ADDENDUM

ADDENDUM NO. [1] Date: October 31, 2019

**RE: WESTERN TECHNICAL COLLEGE
KUMM CENTER COOLING UPGRADES
400 SIX STREET NORTH
LA CROSSE, WISCONSIN 54601
HSR PROJECT NO. 19035**

2 MECHANICAL REMODEL PLAN
 1/4" = 1'-0"

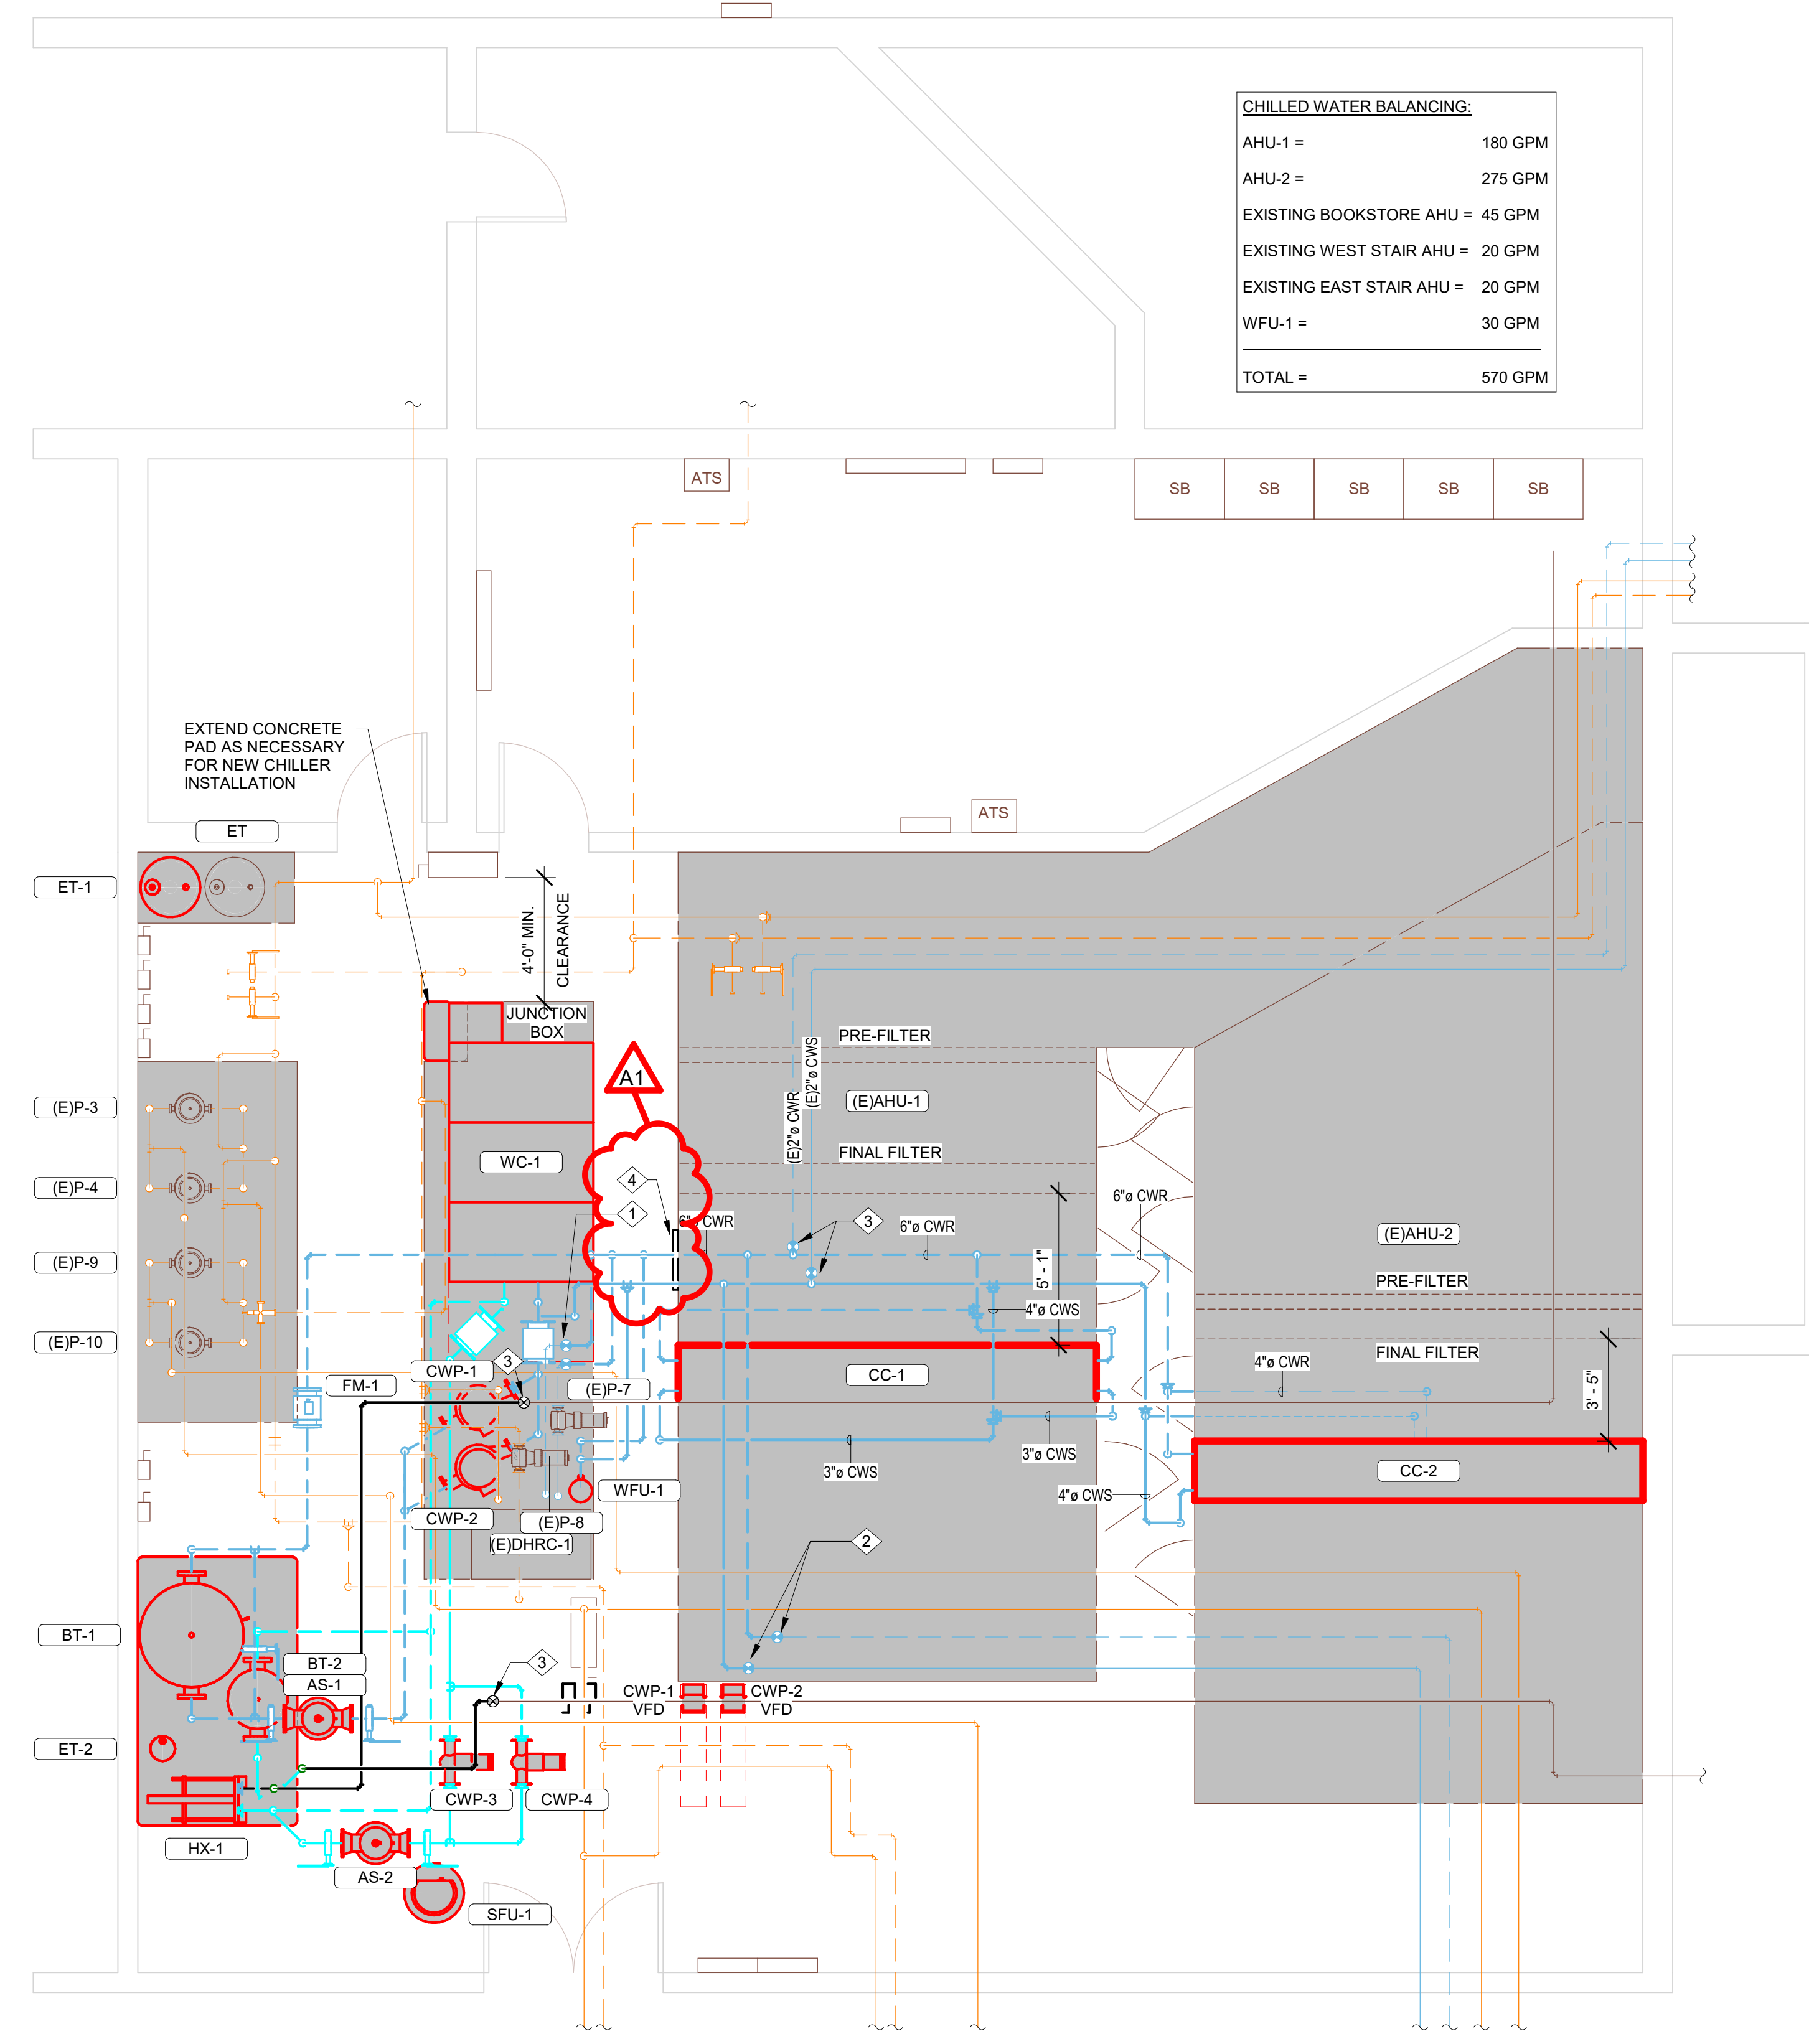
5. Sheet M100 DEMO & REMODEL PLAN 30 x 42 attached hereto
 - a. Revisions clouded on Drawing
 - b. Added access panel to existing (E)AHU-1 along with keynote #4.

1 GEOTHERMAL/CHILLED/HEATING PIPING SCHEMATIC
N.T.S.

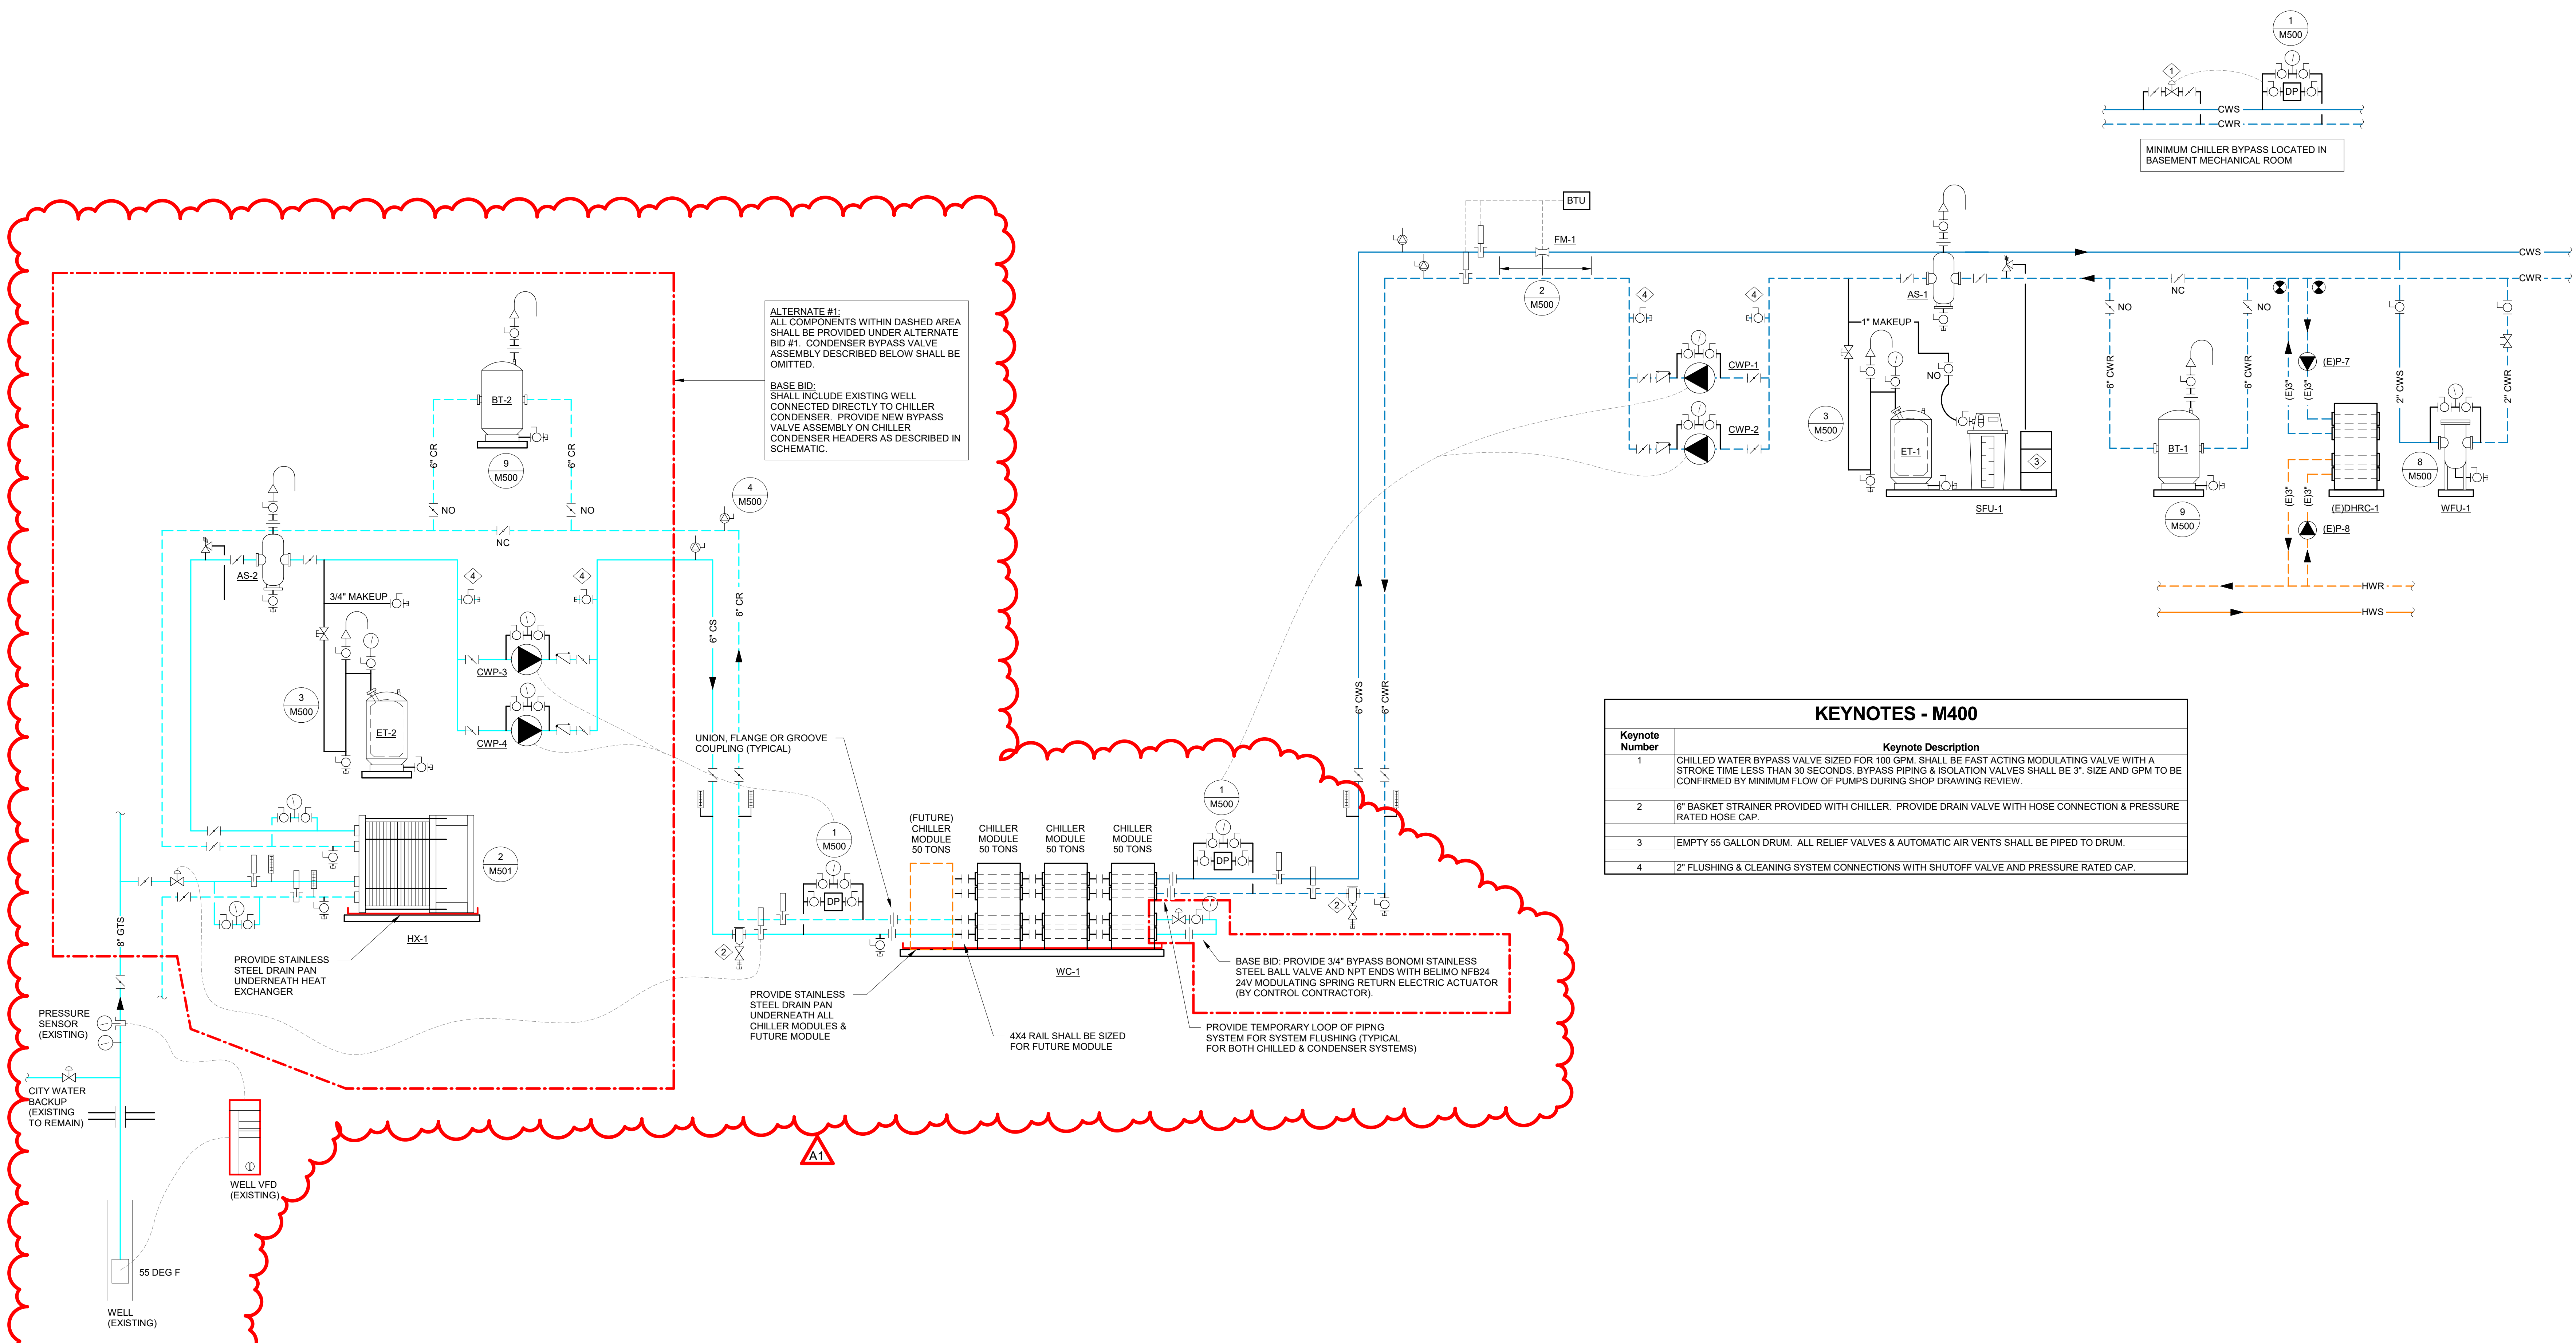
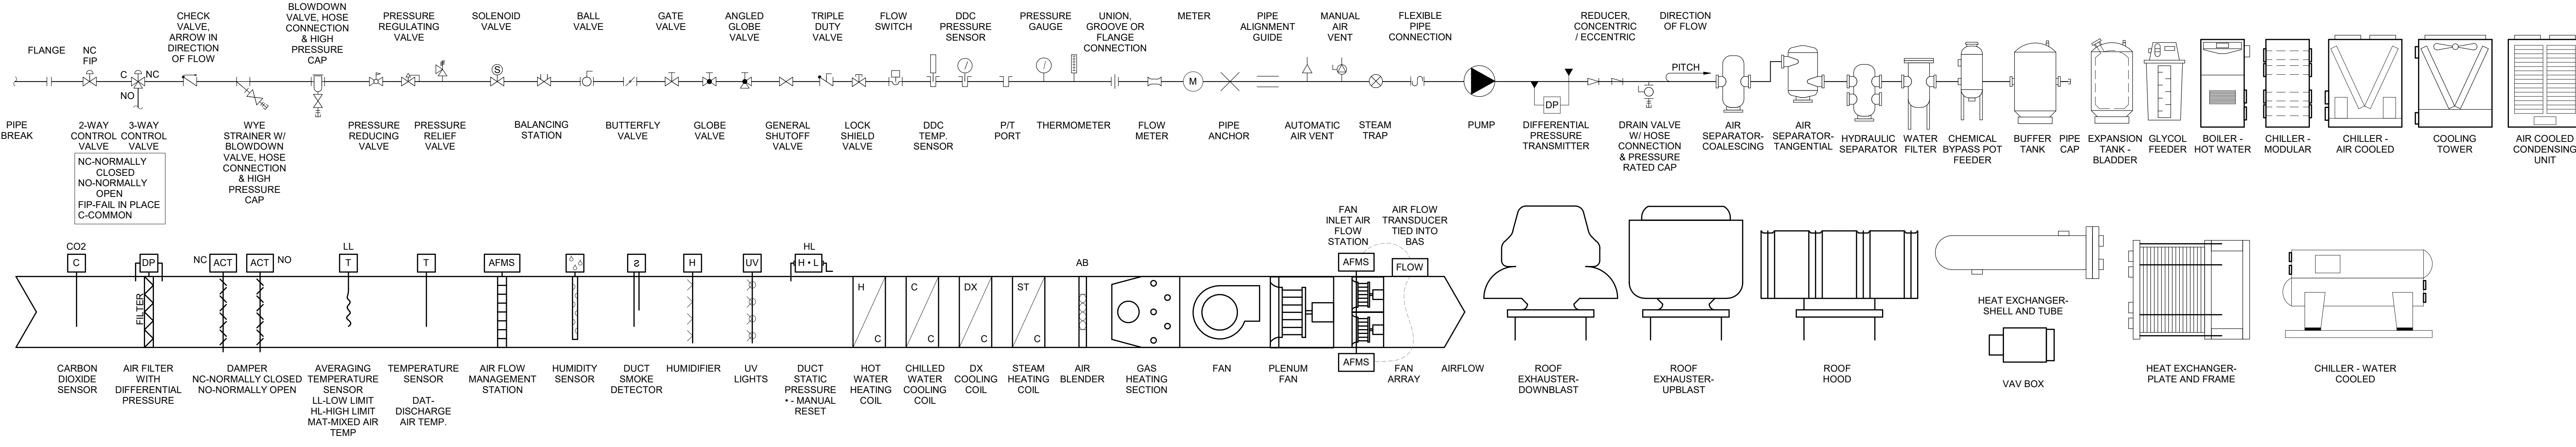
6. Sheet M400 HVAC SCHEMATICS 30 x 42 attached hereto
 - a. Revisions clouded on Drawing.
 - b. Revised existing well pump control. Added 2-way modulating control valve to well-side of heat exchanger.

- c. Added dashed lines indicating Alternate #1 work along with condenser bypass valve noted to be under base bid.
 - d. Existing West Stair AHU shall be provided with new chilled water 3-way control valve.

1 INLINE PUMP DETAIL
N.T.S.

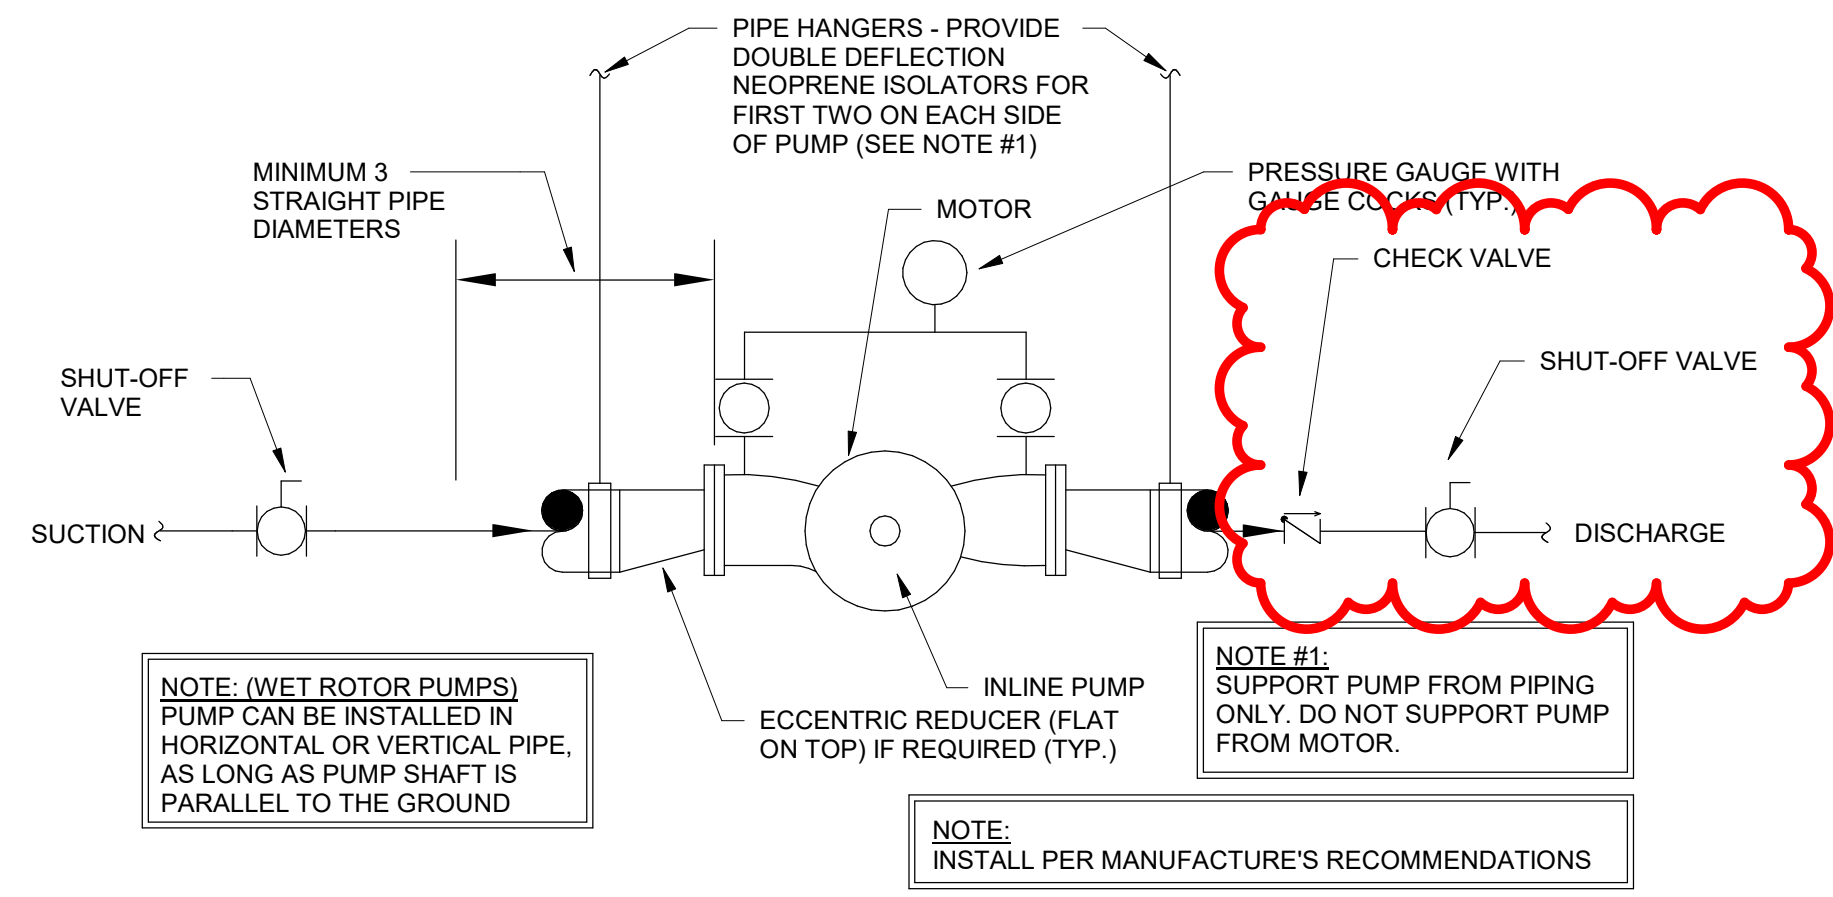
7. Sheet M501 HVAC DETAILS 30 x 42 attached hereto
 - a. Revisions clouded on Drawing.
 - b. Detail 1M501 INLINE PUMP DETAIL: Removed balancing station on discharge piping.
